1 DETAILS OF THE DEVELOPMENT

Ref: 20/02134/PRE

Location: 20-24 Mayday Road, Thornton Heath, CR7 7HL

Description: Demolition of existing commercial (light industrial) buildings.

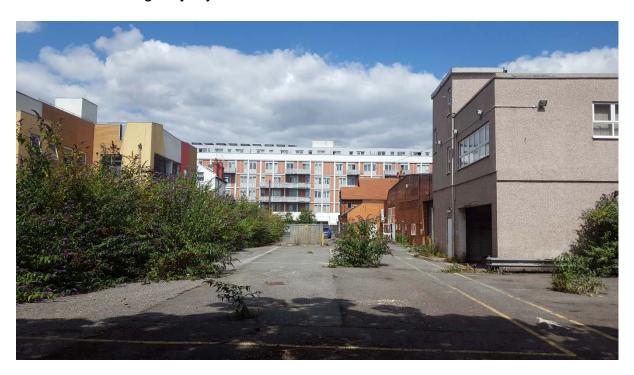
- 4.9 Proposals on this site have the potential to unify a disjointed Mayday Road and set the tone for future development, by improving the quality of the built environment and public realm, and create a residential community set back and largely sheltered from the public streetscene. The aerial photo below highlights the site in the context with its surroundings as well as highlighting the heights of these surrounding developments. It is followed by a couple of photos of the existing site (taken by officers).
